Work Order ID 92391

DRAWING NO. D3016	TITLE SEAT FRAME ASSEMBLY	REV. A	DART AEROSPACE LTD ENGINEERING ORDER	D.E.O. NO. D3016-A-1	SHEET NO. SHEET 1 OF 1	SCALE NTS
DRAWN 1	CHECKED UP	MFG. APPR. E	APPROVED WAP	DE APPR. H		
DATE 10.01.29	DATE 10.01.29	DATE 10.01.29	DATE 10.01.29	DATE 10.01.29	DATE 10.01.29

TO REVISE D3016-11 SADDLE'S HOLE SIZES

D3016-11 SADDLE

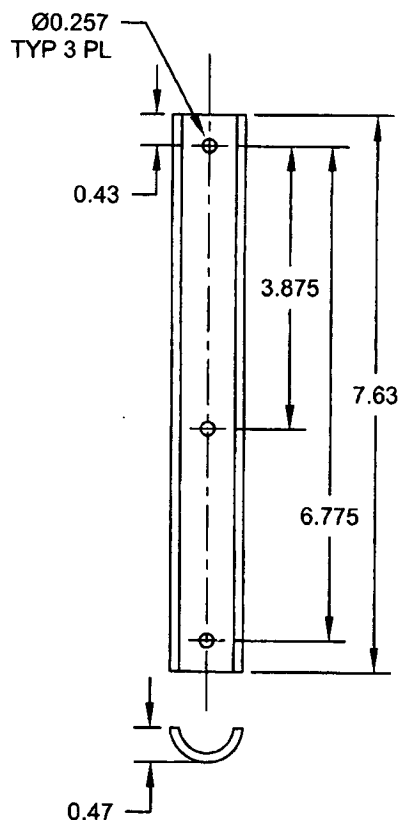
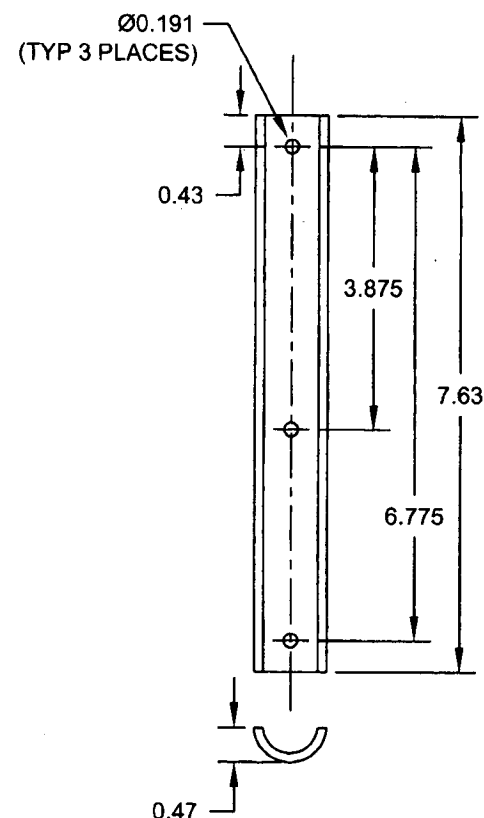
DETAIL D3016-11 SADDLE (SHEET 3): Ø0.257 TYP 3 PL WAS Ø0.191 (TYP 3 PLACES) AS SHOWN:
